**Submission to the Australian Energy Regulator
on
Fair and reasonable charging rates for
CitiPower's Capital Contribution Charge
for Marginal Cost of Network Reinforcement**

14 August 2009

This submission (**Submission**) sets out CitiPower's comments on the Australian Energy Regulator's (**AER**) decision and further consultation on CitiPower's capital contribution charge for its Marginal Cost of Network Reinforcement, dated 17 July 2009 (**Decision**).

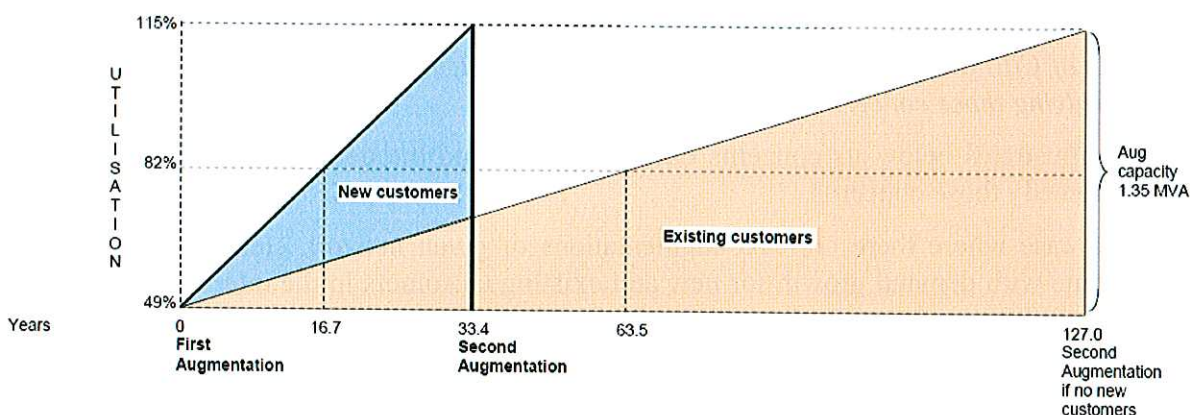
The following diagram shows the timing of the two augmentations and the customer demand and utilisation growth that makes the second augmentation necessary.

Accordingly, 0.49 MVA of new customer demand will have caused the requirement for 1.35 MVA of augmentation capacity to have been brought forward.

The general result is that the new customer bring forward factor is 2.755 (being $1.35\text{MVA}/0.49\text{MVA}$), rather than 1, as implicitly assumed by the AER proposed approach. This new customer bring forward factor (when multiplied by the AER's net present value factor and CitiPower's historical MCR cost) ensures that, in aggregate, new customers' MCR charges will reflect the cost to CitiPower of bringing forward in time the entire augmentation, and that average network utilisation is implicitly assumed to remain constant (at 82%) over time.
